Tuesday, August 18, 2026
Monroe Planning Board Regular Meeting

Project: 20 Owen Drive - 0207-2022

20 OWEN DRIVE SUBDIVISION
TOWN/VILLAGE OF MONROE
COUNTY OF ORANGE, NEW YORK
PROJECT TITLE

PROPOSED SEWER EXTENSION PROFILE

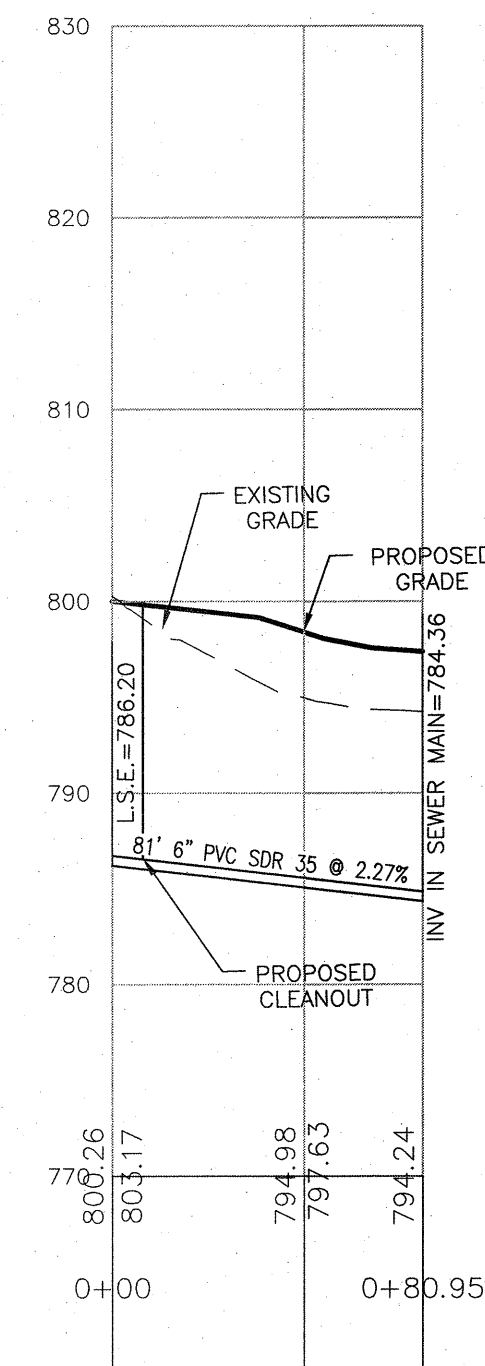
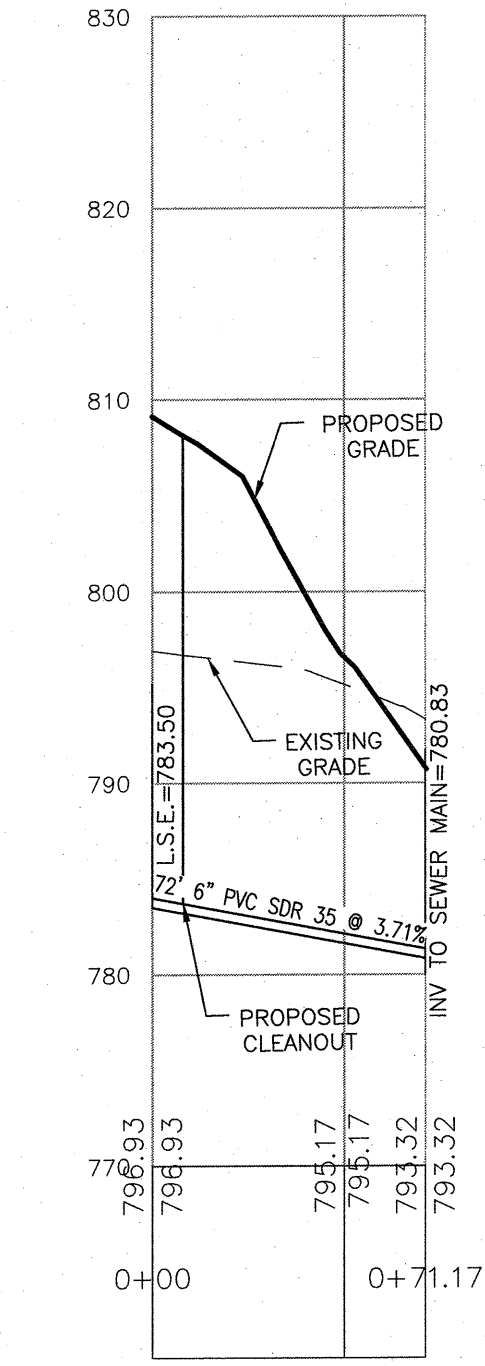
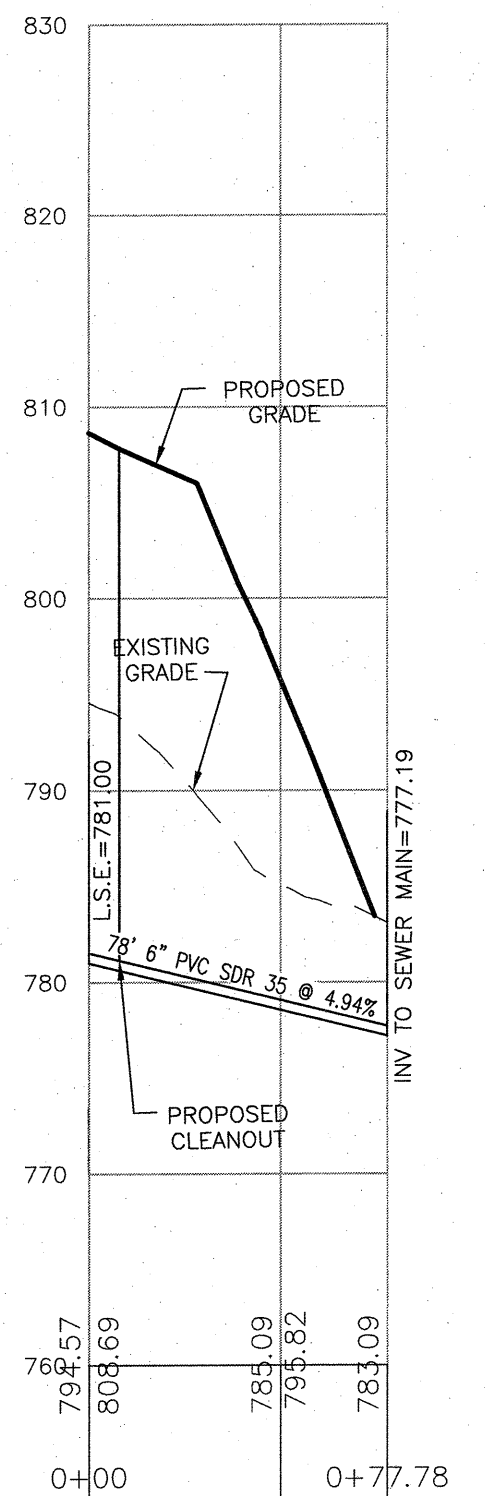
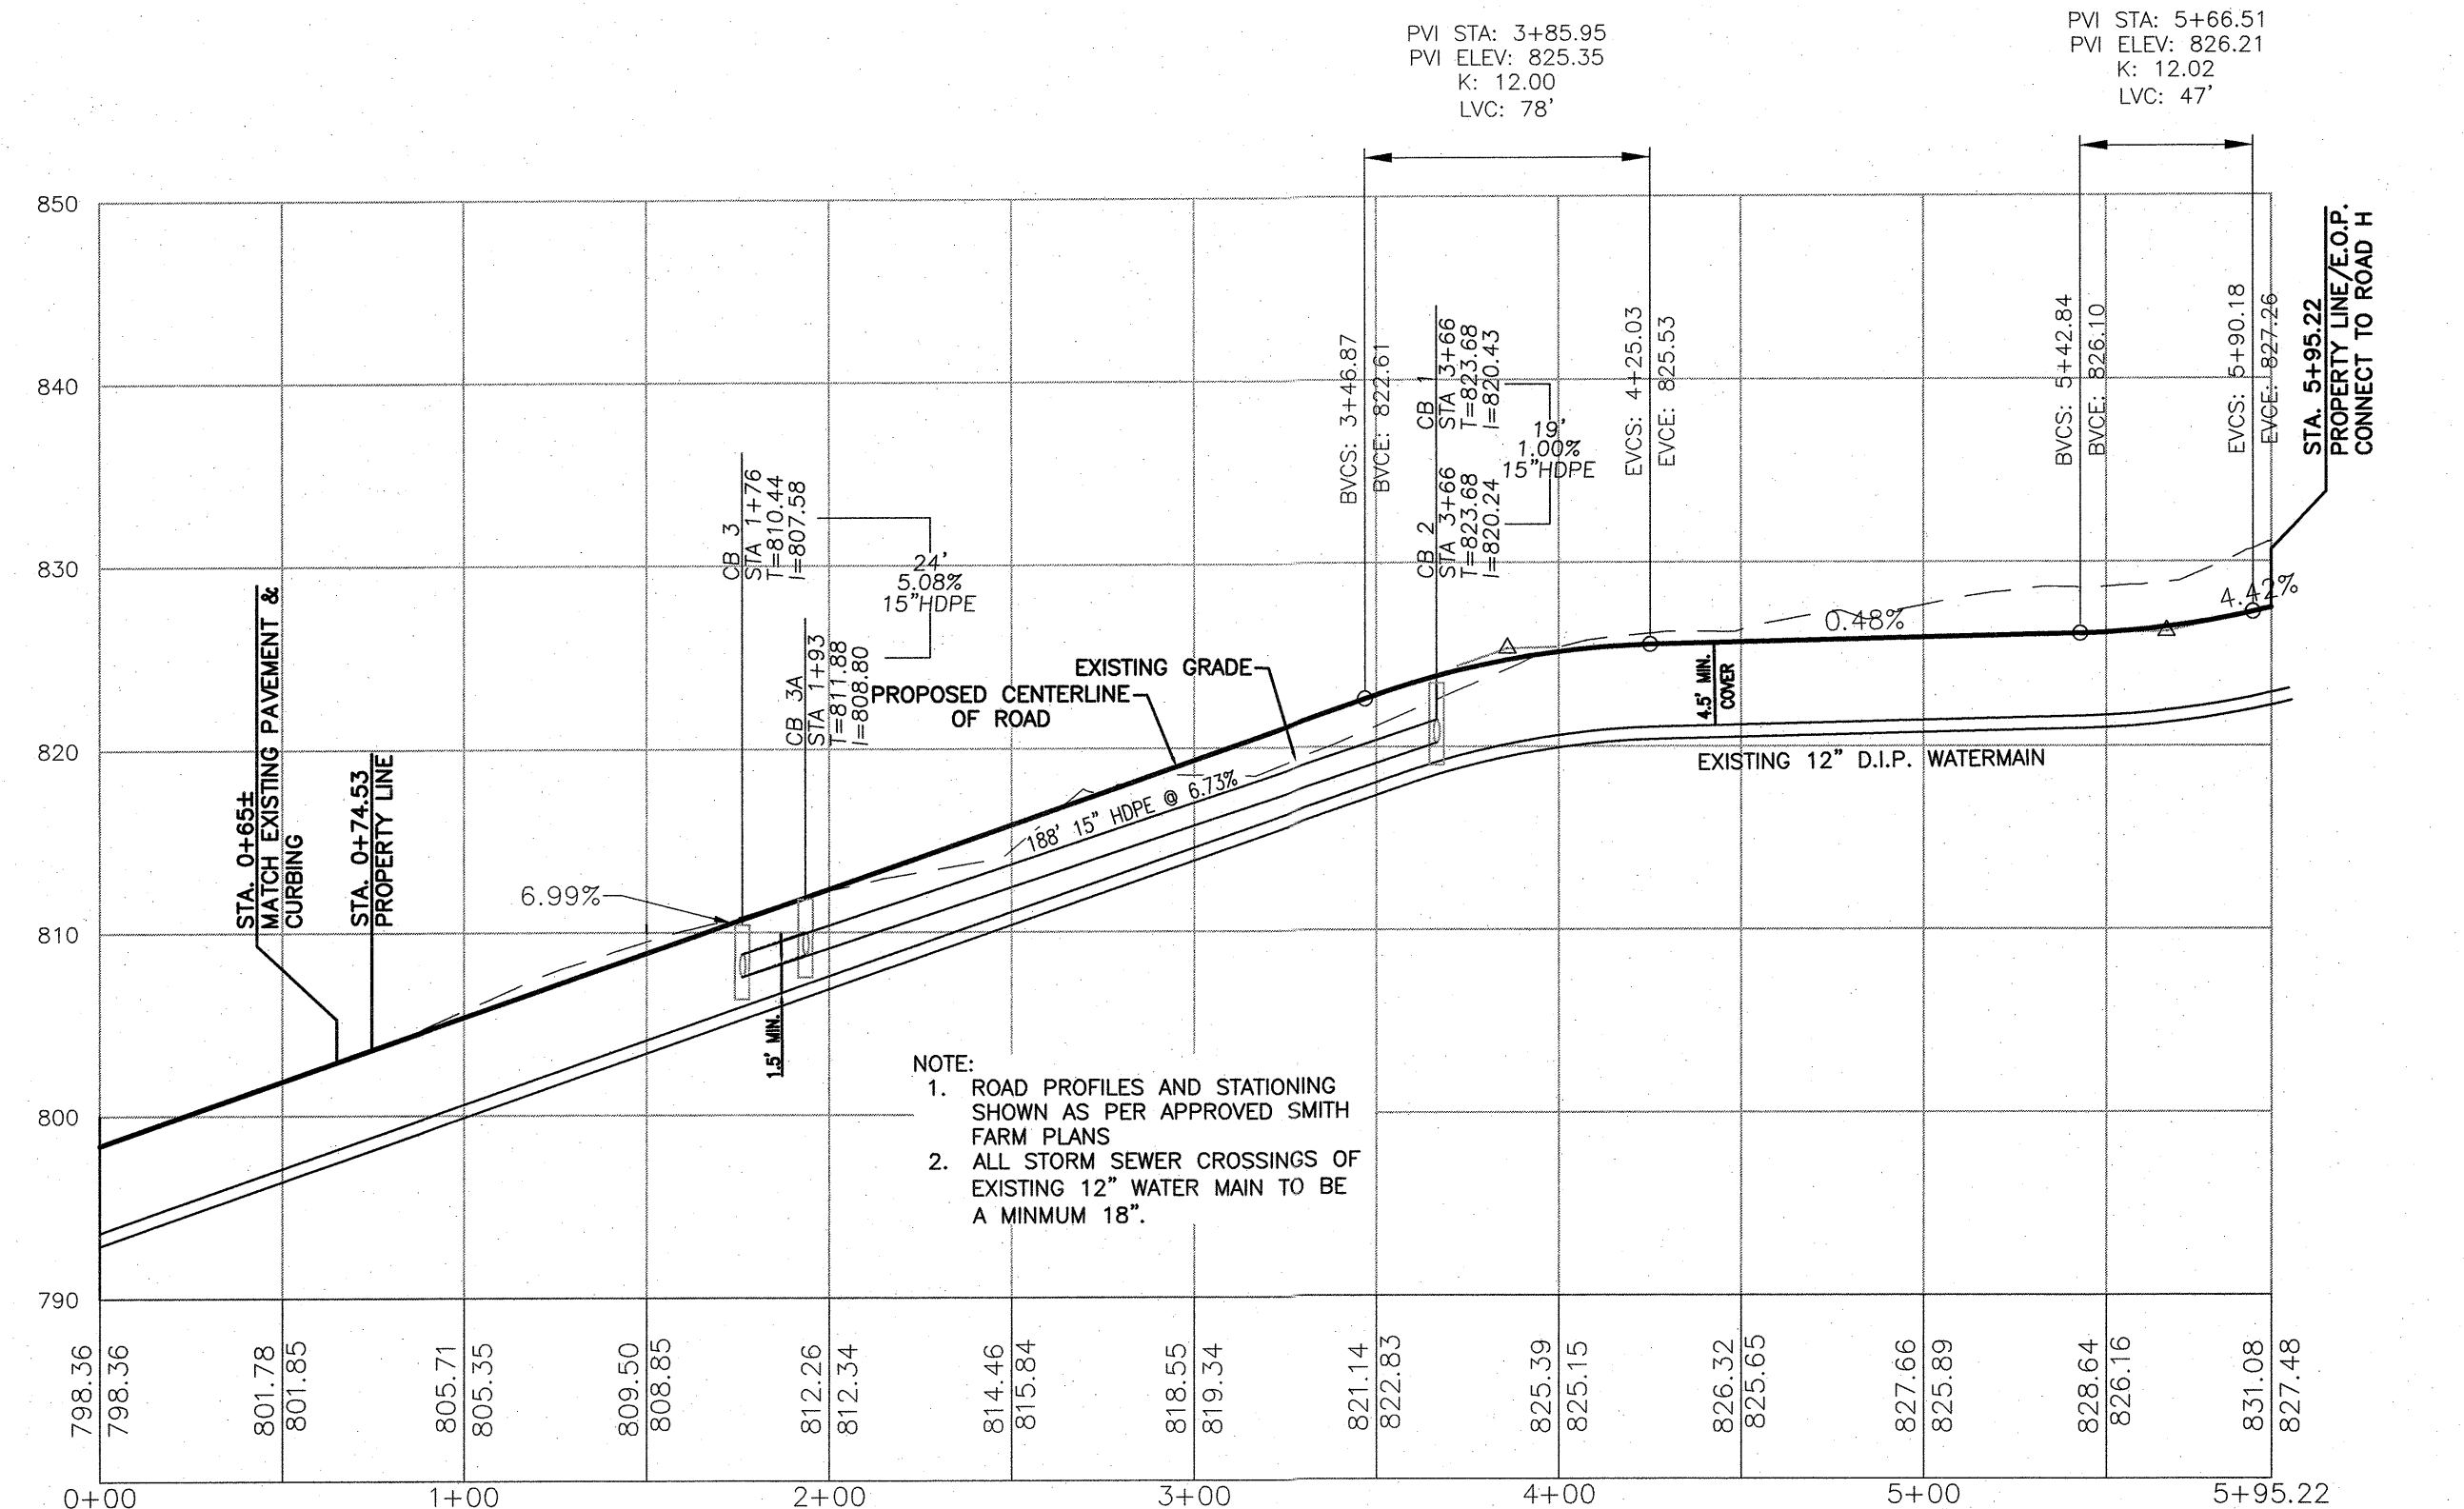
2. *Manhole call out information at connection to existing manhole on Smith Farm does not include new 3rd invert for new connection. Also, the plan invert information does not match Profile information. Please correct.*

A 3rd invert has been provided at the connection to the existing manhole. The plan invert information now matches the profile information.

PROJECT TITLE
LANDSCAPING PLAN

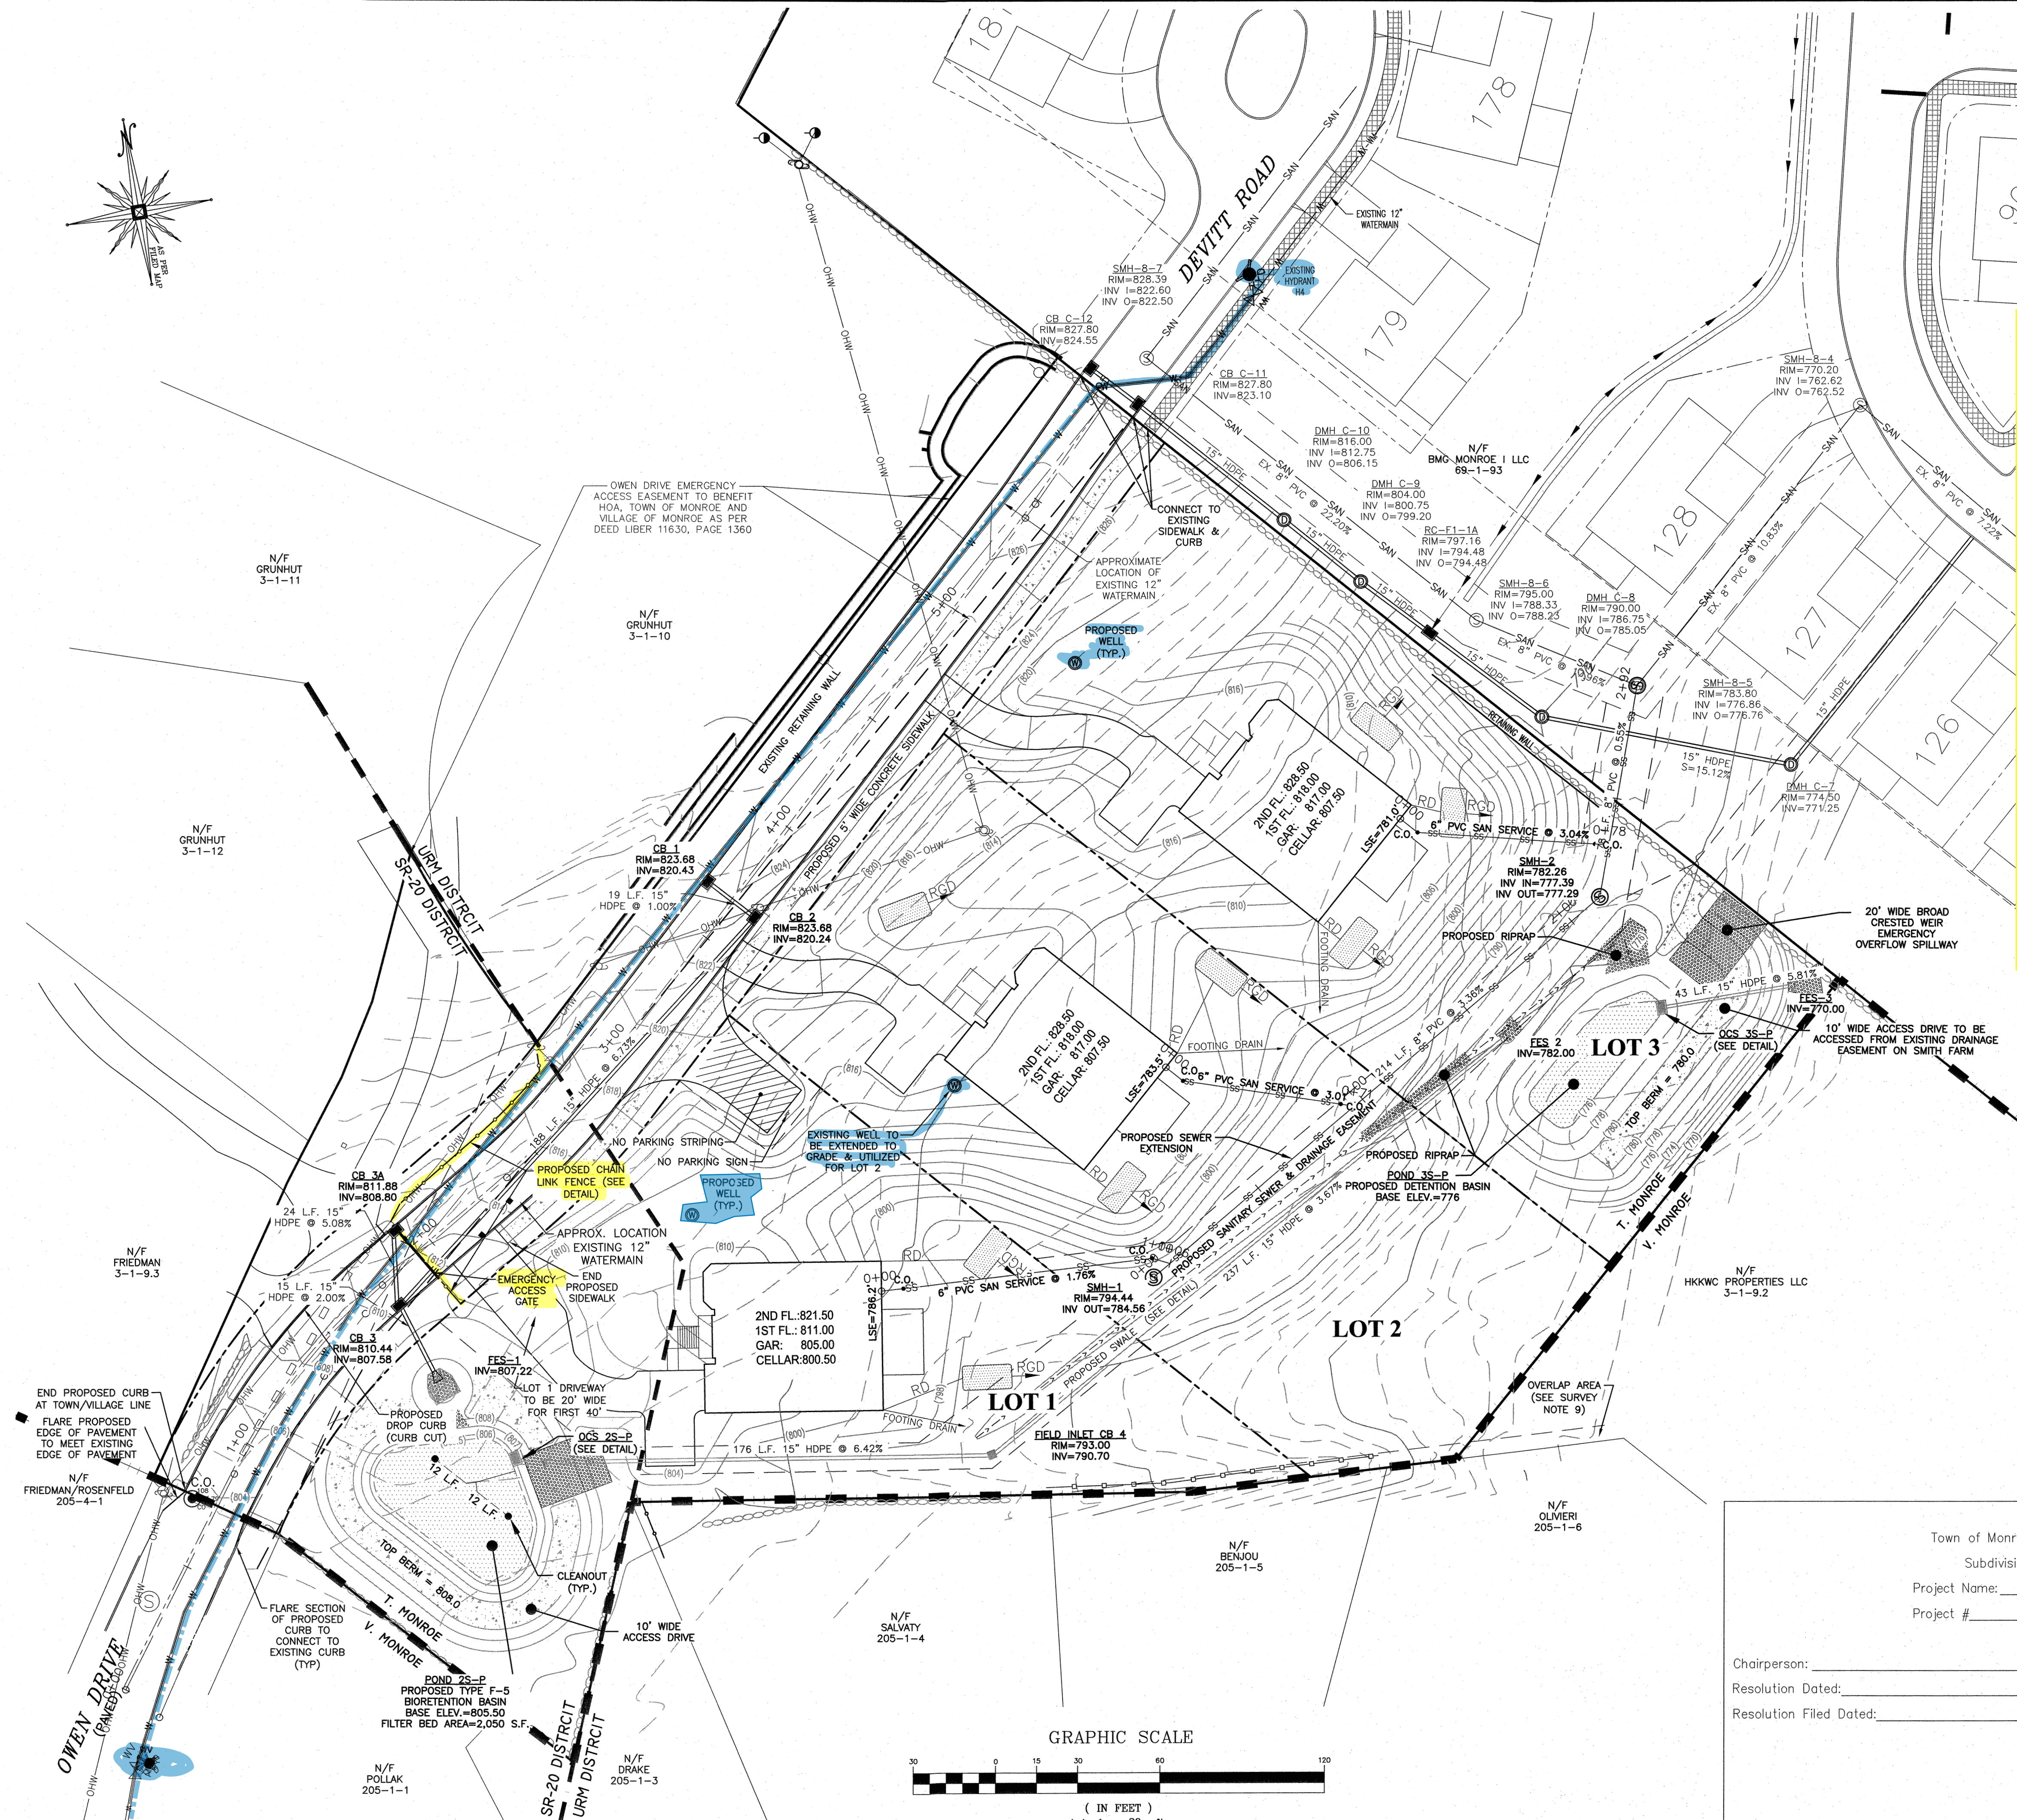
If approved, 20 Owen Drive would need a new tree and shrub plan. A green arborvitae and leatherleaf viburnum are not native to New York.
